We sincerely thank you for the opportunity to revise our manuscript (*Reframing gullies as recharge zones in dryland landscapes of the Loess Plateau, China; egosphere-2025-4065*). We are deeply grateful for the detailed and constructive feedback provided by the reviewers, which has been invaluable in strengthening and improving our work. In response to the reviewers' comments, we have thoroughly revised the manuscript and made the necessary changes. All comments have been addressed point-by-point. Reviewer comments are presented in red, our responses in black, and the revisions to the manuscript in blue. The line numbers in our responses refer to the revised manuscript with no changes marked.

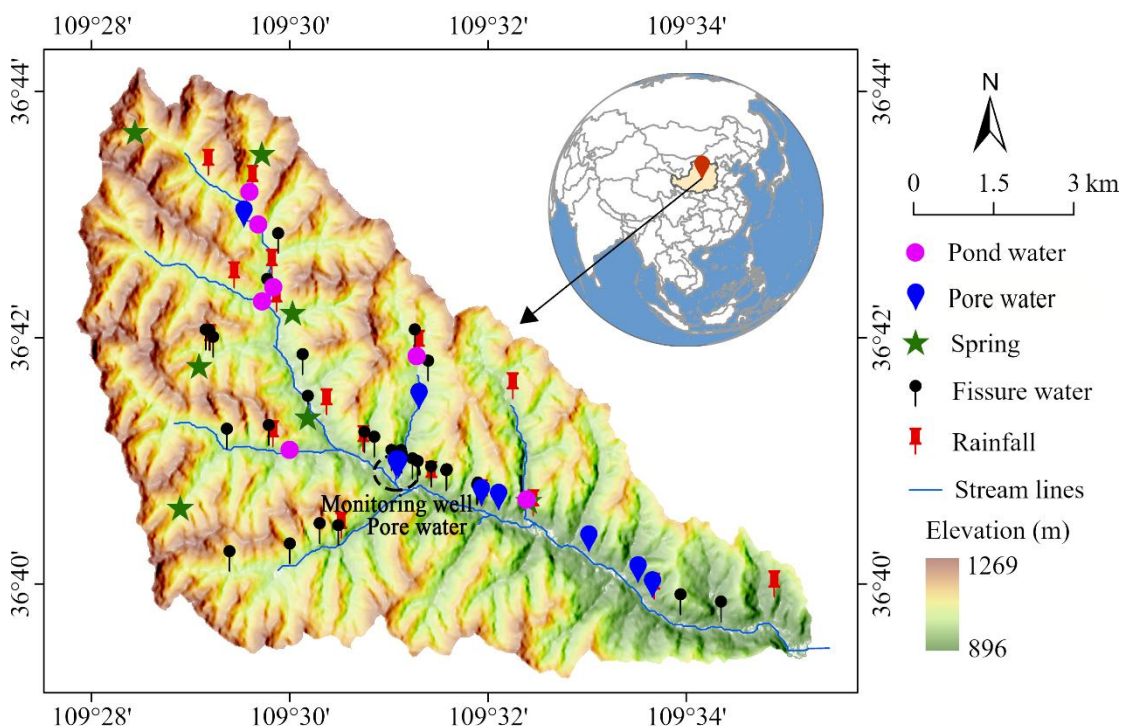
3. Line 180: How many wells in this catchment were monitored? Please show their positions in Figure 2.

Response: The monitoring network in this study includes 35 discrete sampling wells: 9 for pore water, and 26 for fissure water, aimed at characterizing the spatial variability of groundwater hydrochemistry and isotopic signatures. All sampling locations are clearly marked in Fig. 2 (in the original manuscript, and now Fig. 1 in the revised manuscript) of the original manuscript. Additionally, one continuous pore water table monitoring well is installed in the middle reaches of the catchment to quantify groundwater table fluctuations and estimate recharge rates. In response to your comment, we have updated Fig. 2 (in the original manuscript, and now Fig. 1 in the revised manuscript) to include the location of this monitoring well. The specific revisions are detailed below.

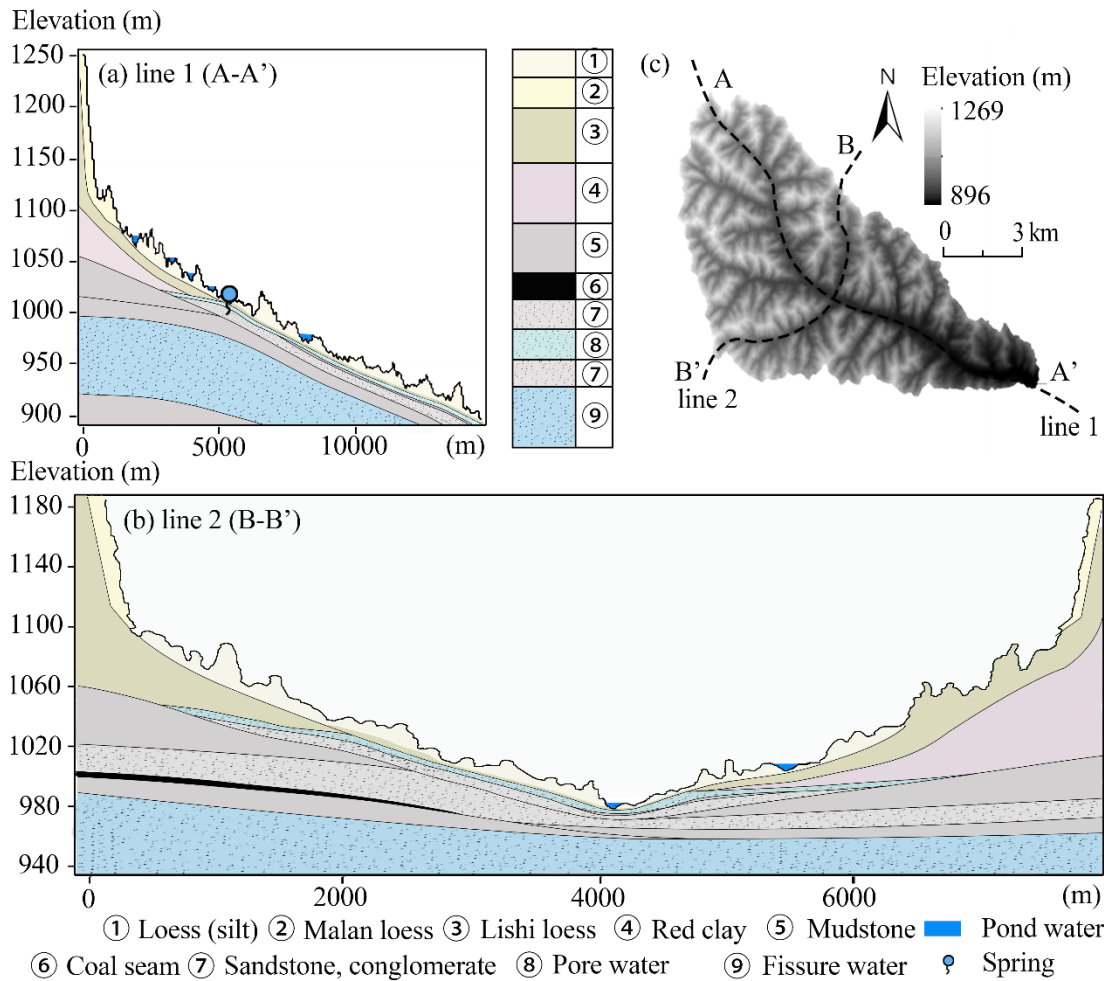
1. Fig. 3a and 3c lack units on the x-axis. Additionally, the directions of profiles Line1 and Line2 should be clearly indicated in Fig. 3b.

Response: We appreciate your comment and have made the necessary revisions. The units on the x-axis have been added to both Fig. 3a and 3b. Additionally, the directions of the profiles Line 1 and Line 2 have been clearly indicated in Fig. 3c. The specific additions are as follows:

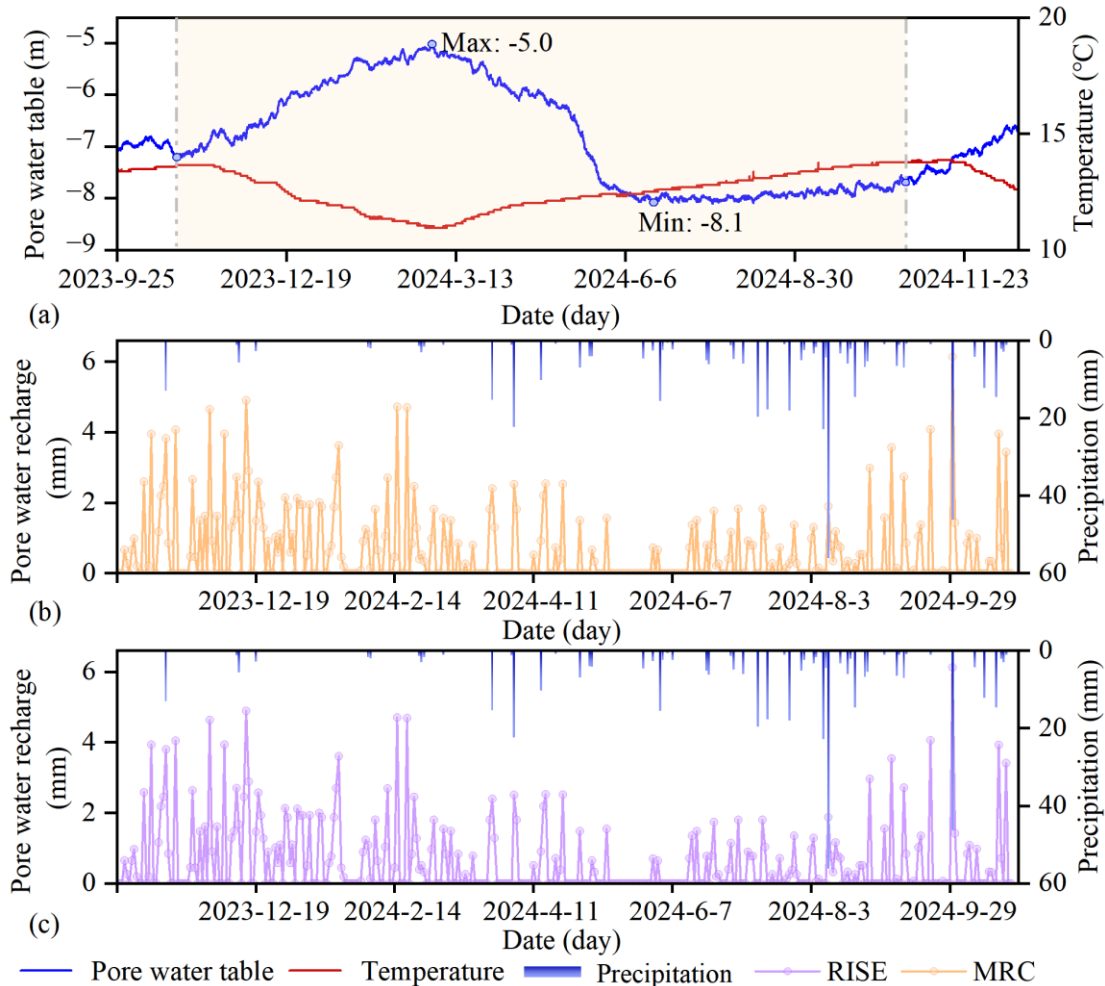
2. The terms 'Pore water table' and 'Porous water table' in Fig. 9a should be standardized for consistency.

Response: We have addressed this comment by standardizing the terminology in Fig. 9a (in the

original manuscript, and now Fig. 10a in the revised manuscript), consistently using “Pore water table” throughout. Additionally, we have reviewed the entire manuscript and made similar revisions to ensure consistency across all related expressions. The specific additions are as follows:

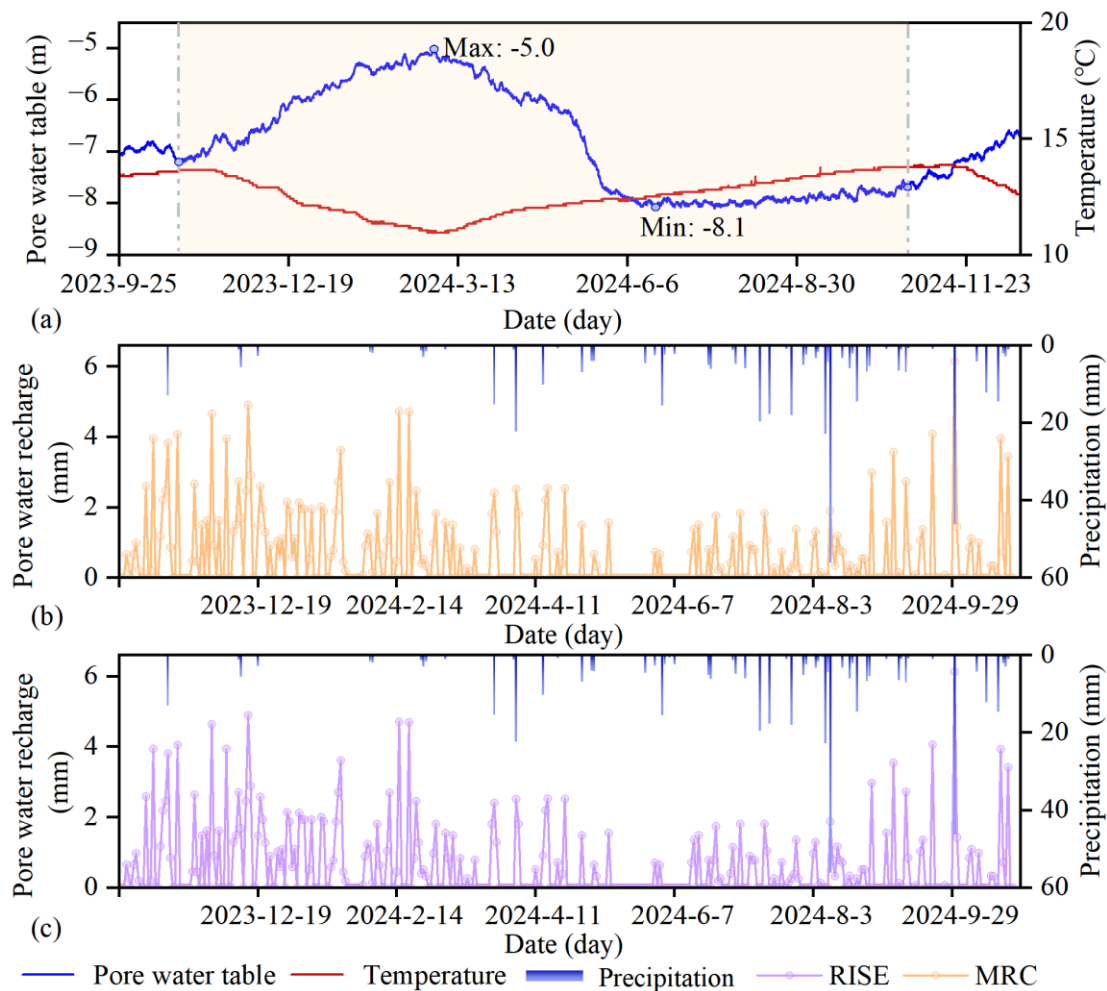
3. In Fig. 9b, the overlap of 'pore water recharge' and 'precipitation' affects the visibility of the recharge results. It is recommended to display precipitation separately or on the upper axis of the figure.

Response: In the original manuscript, we placed the precipitation and pore water recharge data on the same axis to better illustrate their synchronous relationship, which led to some visual overlap. Following your comment, we have moved the precipitation data to the upper axis of Fig. 9b (in the original manuscript, and now Fig. 10b in the revised manuscript), ensuring that the visibility of the recharge results is not obstructed. The specific revision is as follows:

Fig. 7. Chloride concentration of various water sources in the rainy and dry seasons (a), and the spatial relationship between chloride concentration and $\delta^{18}\text{O}$ for different water sources (b).” (Lines 471-479)

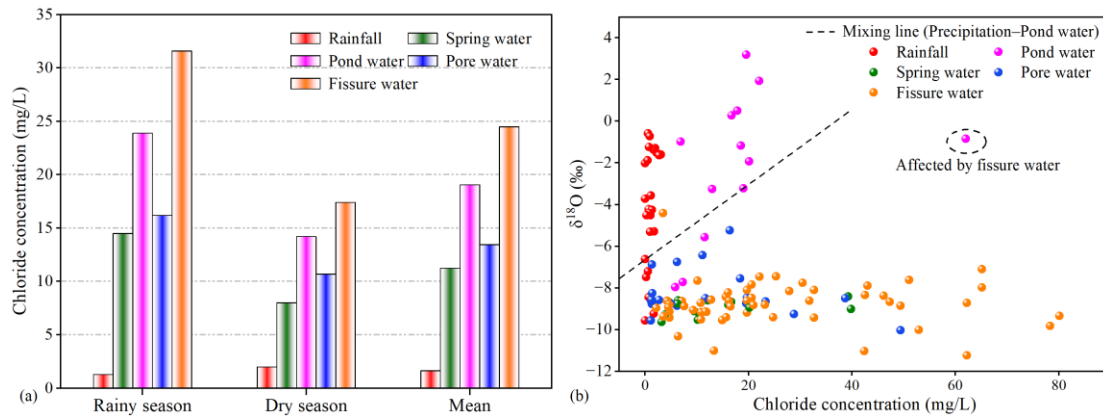
• Lines 547–552: The argument that similarities in chloride concentrations between pond water and pore water indicate mixed recharge is not logically developed. Chloride patterns alone do not necessarily imply source mixing without additional constraints (e.g., conservative behavior, spatial gradients, mass balance, or exclusion of evaporative concentration effects). The logic linking chloride distributions to the stated conclusions should be clarified and strengthened, or the claims should be toned down.

Response: Based on your comments, to strengthen the logical rigor of the conclusion regarding the similarity in chloride concentrations between pond water and pore water, we first confirmed the differences in chloride concentrations among various water sources. We then introduced the spatial relationship between $\delta^{18}\text{O}$ and chloride concentrations to further compare concentration variations across different water bodies at distinct locations. The results indicate a correlation between the distribution patterns of chloride concentrations and $\delta^{18}\text{O}$, providing additional support for the hypothesis of potential mixed recharge between pond water and pore water. The specific additions to the manuscript are detailed as follows:

“Complementing the isotope data, Cl^- levels in pore water consistently fall between those of precipitation and pond water across both seasons (Fig. 7a), and the correlation pattern between chloride concentration and $\delta^{18}\text{O}$ supports a mixed recharge origin for pore water (Fig. 7b). This trend aligns with the isotopic evidence from the rainy season and supports the interpretation that pond water contributes to pore water recharge via vertical percolation through the vadose zone, particularly during high-rainfall periods when infiltration capacity is exceeded.”

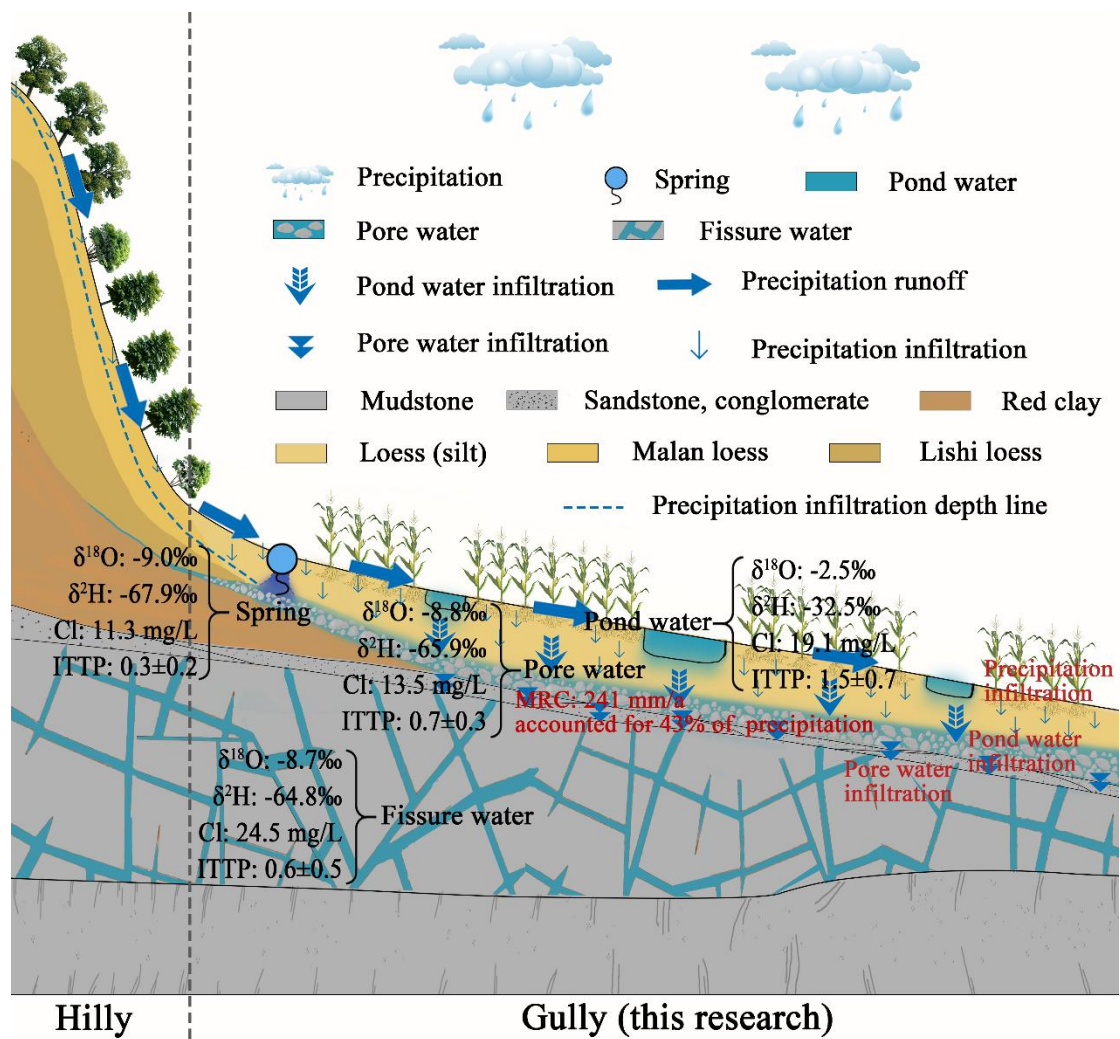
- Explicitly state which components or pathways are supported by results from this study and which are drawn from previous literature;
- Redraw the figure to include quantitative or semi-quantitative information (e.g., relative magnitudes, ranges, or percentages of pathways) where supported by data.

In its current form, the conceptual figure does not clearly highlight new insights generated by this study, and instead risks reinforcing a narrative largely based on prior work.

Response: Thank you very much for your constructive comment. In response to your General comment #1, we have thoroughly revised the Introduction section, emphasizing the novelty and scientific significance of groundwater recharge processes in gully areas under engineering interventions. This study specifically focuses on hydrological processes within the valley zone and does not directly address hillslope hydrology. When referring to the hilly area, we have positioned the hillslope solely as a contributing source of runoff into the valley, drawing on previous study findings and our own field observations. The core framework of this study can be summarized as follows: surface runoff from the upland hillslope converges into the gully, where it is intercepted by check dams, forming pond storage that subsequently recharges groundwater.

Following your comment, we have redrawn Fig. 10 (in the original manuscript, and now Fig.

11 in the revised manuscript) to clearly define the spatial scope of this study as the gully area, with specific annotations for clarity. Accordingly, we have systematically reviewed and revised the Discussion section to ensure that all analyses, inferences, and conclusions are tightly focused on the hydrological processes within the gully area. The revisions are as follows:

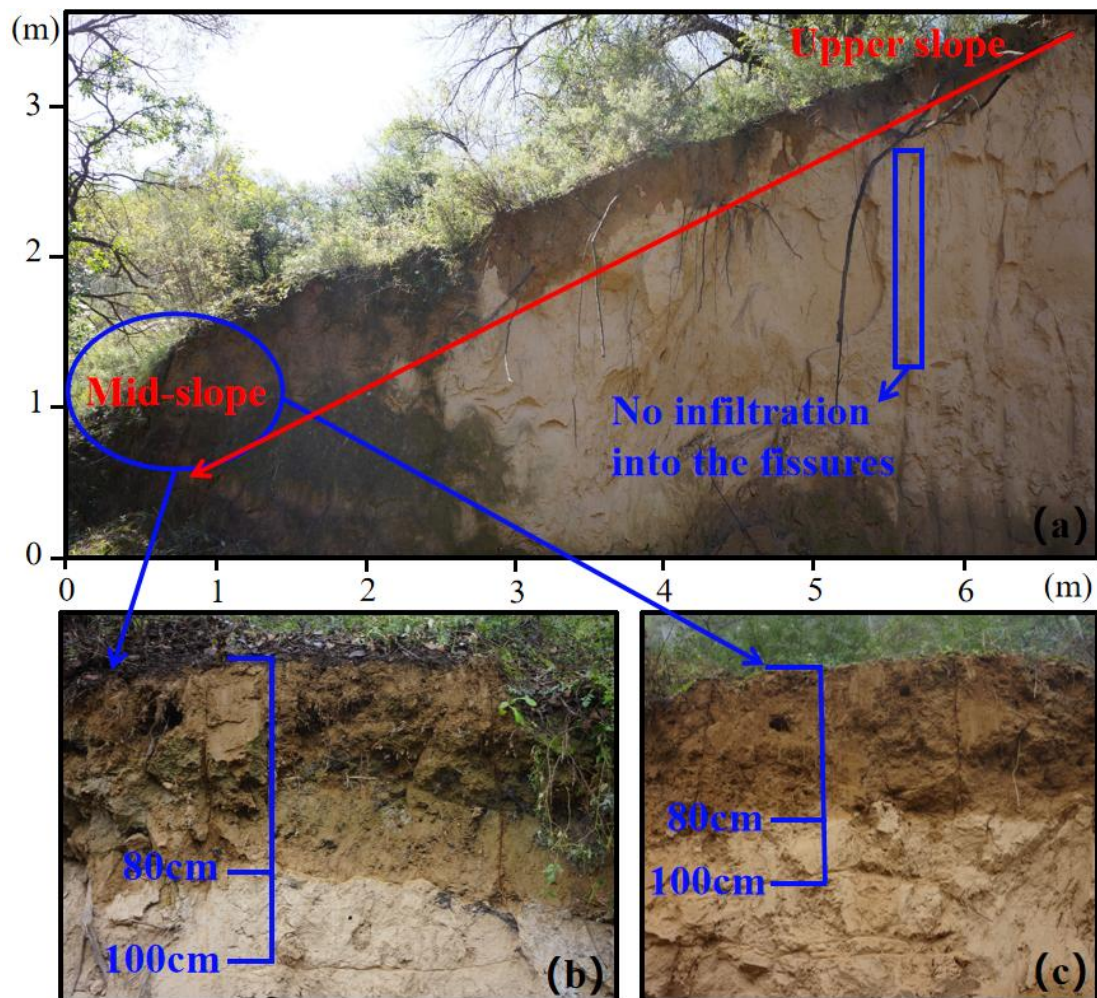
1. Fig. 1: Please label the horizontal and vertical scale of the hillslope profile. Without scale information, the geomorphic interpretation is unclear. And consider to switch the order of Fig. 1 and 2.

Response: Following your comment, we have added clear scale information to the hillslope profile. Specifically, both horizontal and vertical scale bars have been included to ensure a clear and accurate interpretation of the geomorphological features. The revised Fig. 2 (in the revised manuscript) is as follows:

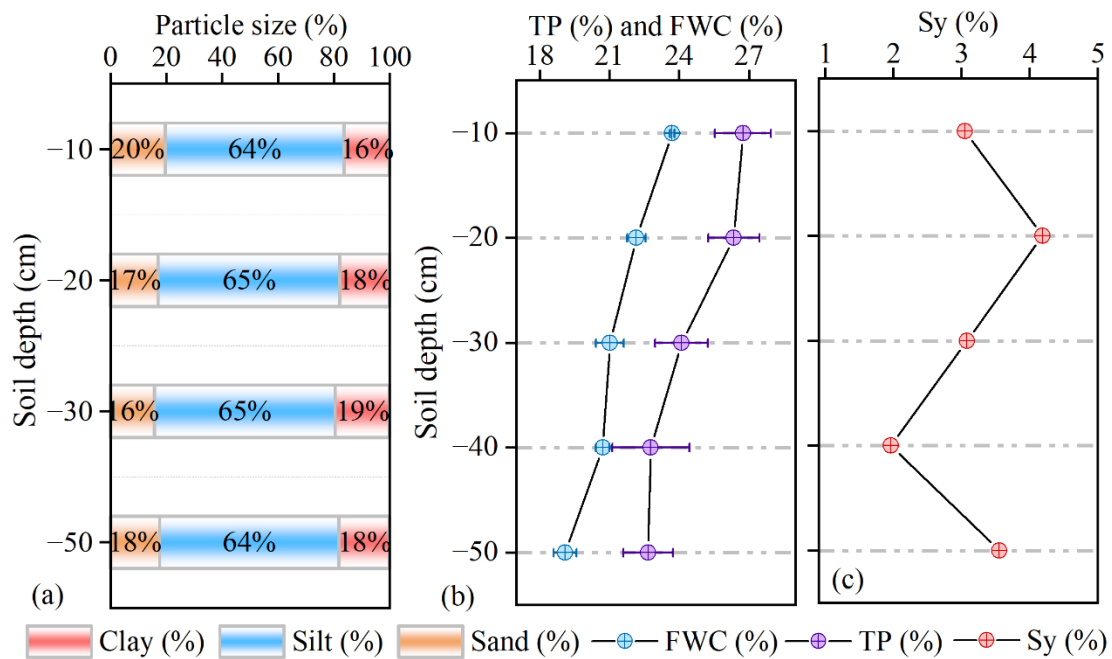
3. Lines 428–430 / Fig. 4c: Fig. 4c does not show a consistently decreasing trend of specific yield with depth. The statement that “Specific yield (Sy) peaks at –20 cm (4.5%) but decreases with depth” is not convincingly supported by the figure. The interpretation that deeper layers “store water with minimal drainage” therefore appears overstated and should be revised or better supported.

Response: Following your comment, we have revised the figure captions. The specific revisions are as follows:

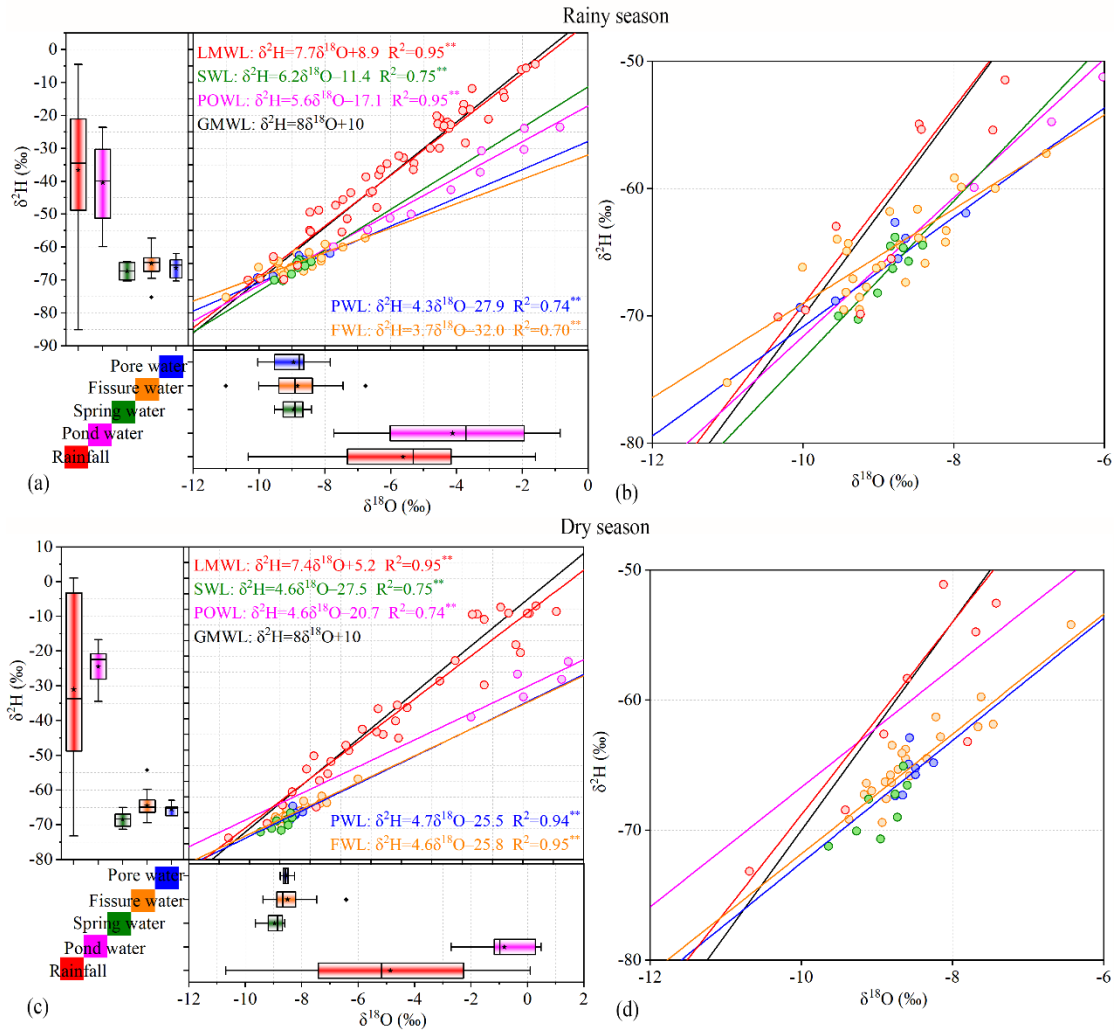
4. Fig. 5: The current representation of rainy versus dry seasons is unclear. The figure does not effectively illustrate isotopic differences between seasons, making the associated text difficult to support. Presenting seasonal mean values (or distributions) for each water type would likely convey the message more clearly.

Response: We agree with your comment that Fig. 5 provides relatively limited information on isotopic data for the wet and dry seasons. To more systematically and comprehensively present the seasonal characteristics of isotopic values across various water bodies, we have supplemented the data in Fig. 6 and Table A2 in the original manuscript. Specifically, the box plots in Fig. 6 visually display the distribution range, median, and variability of $\delta^{18}\text{O}$ and $\delta^2\text{H}$ for each water source during both wet and dry seasons, facilitating comparison of overall seasonal differences and variation patterns. Table A2 provides statistical metrics, such as mean values and standard deviations, for each water type's isotopes during both seasons, enabling a quantitative comparison. The specific details are as follows:
